**TOWN OF HERNDON, VIRGINIA
ARCHITECTURAL REVIEW BOARD
WORK SESSION AGENDA
FEBRUARY 5, 2020
HERNDON COUNCIL CHAMBERS BUILDING
765 LYNN STREET
7:30 P.M.**

Case Number & Type: ARB #20-005; Wall Signs
Case Summary: Install new business signs on an exterior wall of an existing multi-tenant commercial building
Case Location: 311 Spring Street, Herndon – Reston Industrial / Business Park

PROJECT TITLE:
AR Workshop

2 ELEVATION DETAIL - TOTAL SF = 19.91
SCALE: 3/4" = 1'

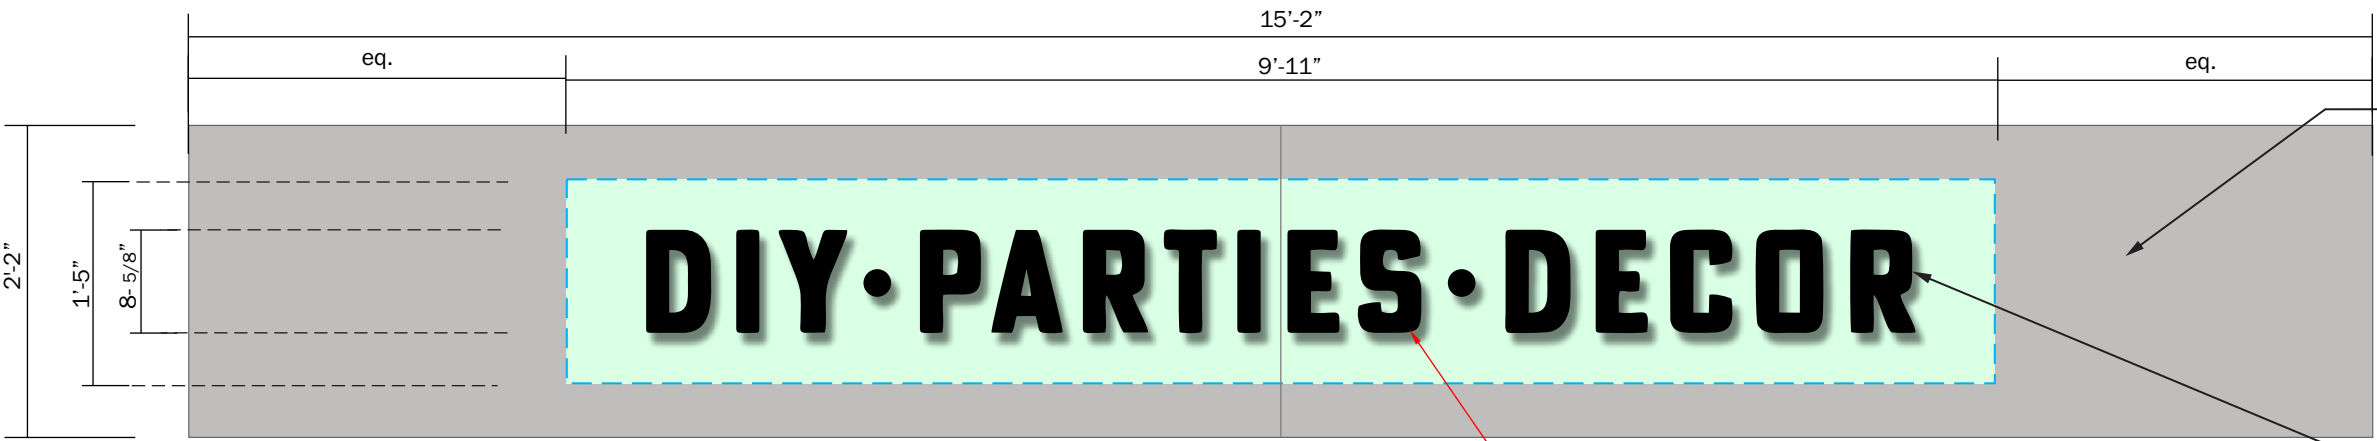
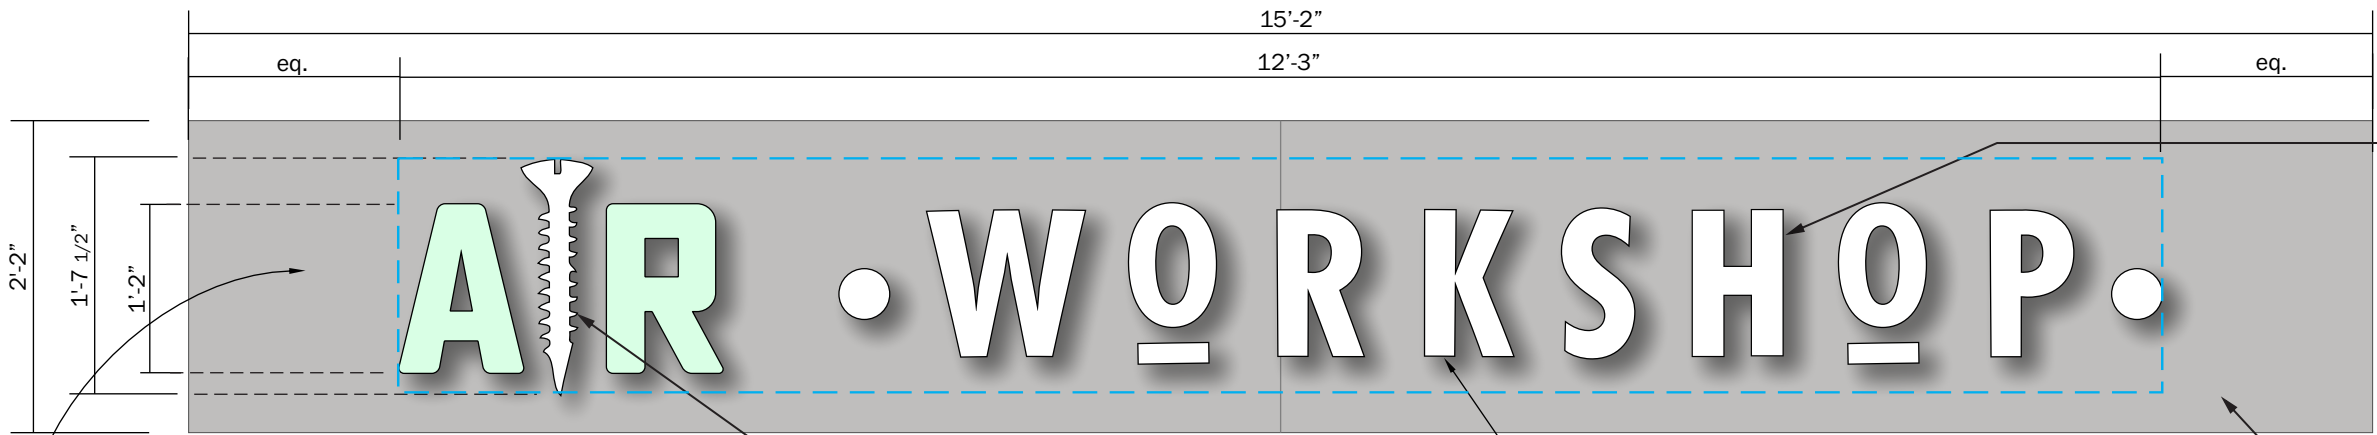
On the second sign panel, *AR Workshop* with incorporated (secondary) logo, will be constructed in an identical manner as the first sign panel (when viewed from left to right). The sign will be approximately 1'-7" tall by 12'-3" wide and will occupy approximately 19.35 square feet. The *AR* lettering will be constructed of approximately 1'-2" tall X 9" wide channel letters with 5" deep aluminum returns, 3/4" black trim caps with a 3/16" translucent white acrylic faces and a translucent *Frosted Coke Bottle Green* (3M vinyl film applied to the white acrylic surface. The *Workshop* lettering and integrated logo will be constructed identically as the *AR* lettering except the acrylic faces will be translucent white. The lettering and logo will be internally lit with white LED lights so that the letters and logo illuminate in the color of the acrylic faces. The *AR Workshop* lettering appears to be mounted over an unidentified material and appears to be incorrectly drawn in the applicant submission materials.

Staff has noted that the sign design of the AR Workshop sign panel shows an unidentified gray material behind the channel letters. Staff has made a presumption that the approximately 1'-7" tall by 12'-3" wide panel dimensions shown in the drawing is the desired panel size which is used to calculate the sign area (see Sheet GF-100, Attachment #1) and meets the zoning ordinance. This discrepancy will need to be clarified and/or corrected to meet the applicant's desired design and assure compliance with the Town's Zoning Ordinance requirements, in order to be considered by the Board.

1 ELEVATION VIEW - SPRING STREET
SCALE: 1/16" = 1'

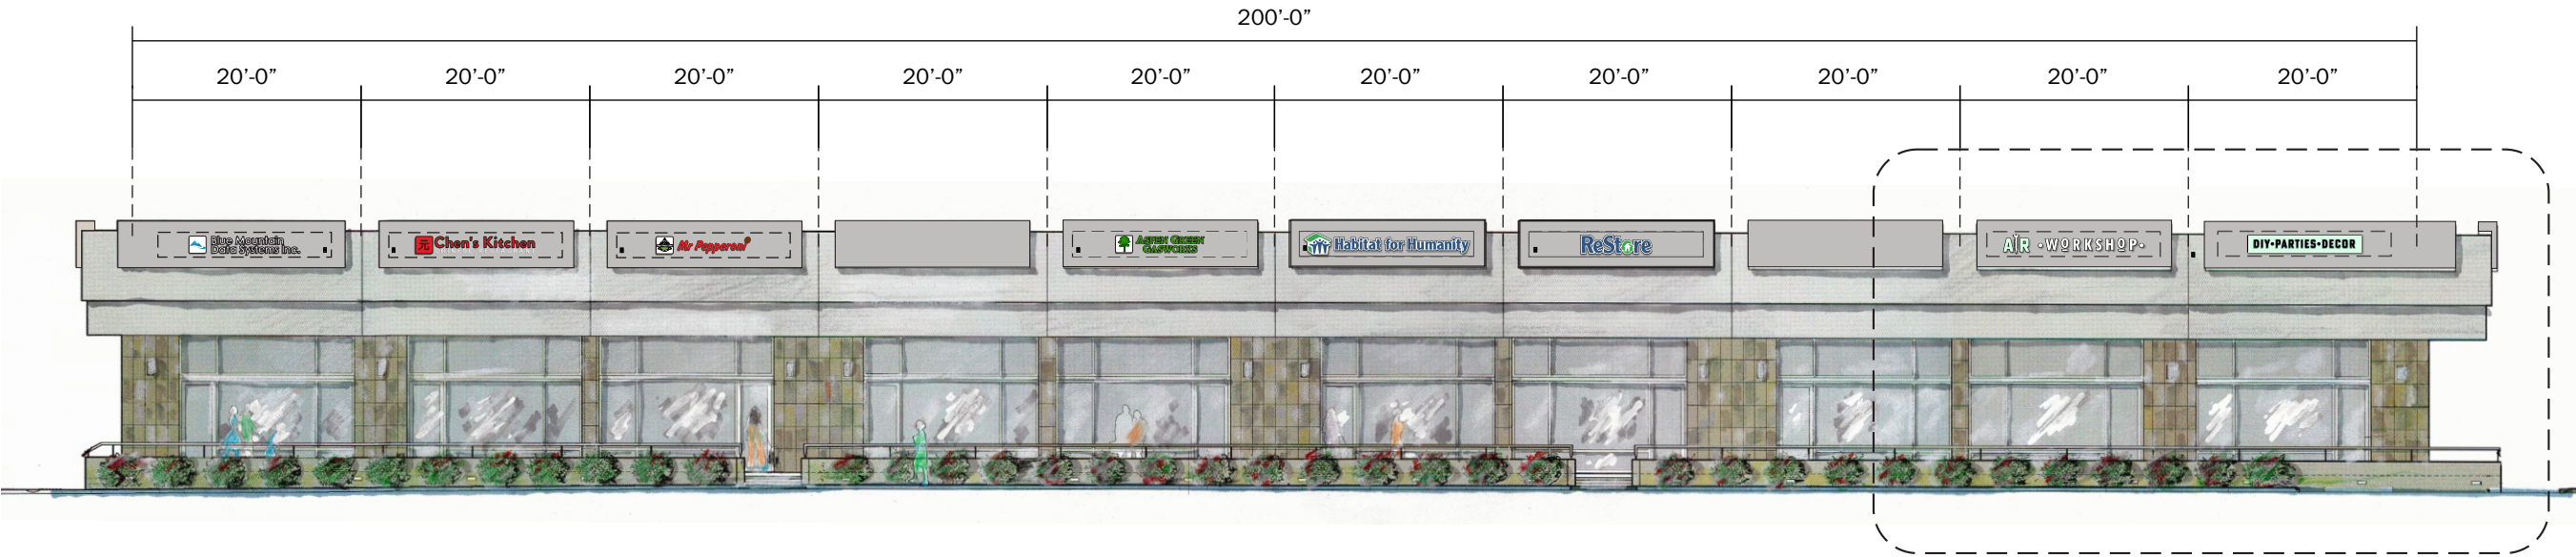
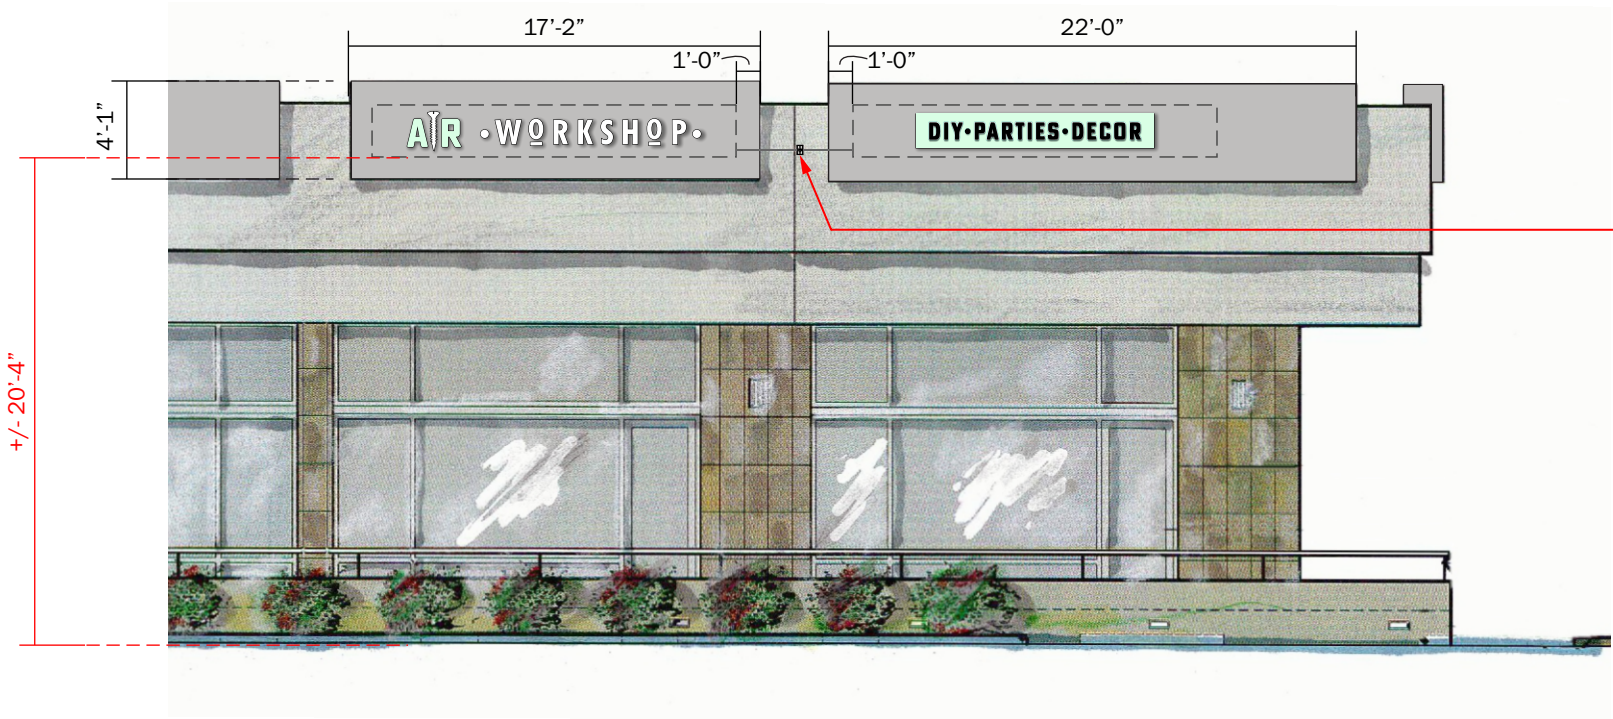
However, staff has also note that the *DIY – Parties – Décor* sign on the building elevations on Sheet A-100 (Attachment #3) is placed off-center on the pre-designed sign panel. Staff recommends the Board discuss this sign placement with the applicant. Staff also recommends that the sign be centered on the sign panel as has been consistently approved for this property and in accord with the Master Sign Plan intent.

Motion Alternatives:	1. Motion to deny the application. 2. Motion to approve the application as submitted. 3. Motion to approve with condition(s). 4. Motion to continue public hearing to a date certain or the next ARB Public Hearing for action to address a specified design issue or concern of the Board.
Recommended Motion:	Staff is withholding its recommendation until the following design issues are clarified or revised: 1) Clarification of the design of size, material and placement of the gray backing material shown behind the <i>AR Workshop</i> lettering (Sheet GF-100, Attachment #1); and 2) Clarification of the placement of the <i>DIY-Parties-Décor</i> sign on the pre-designed sign panel
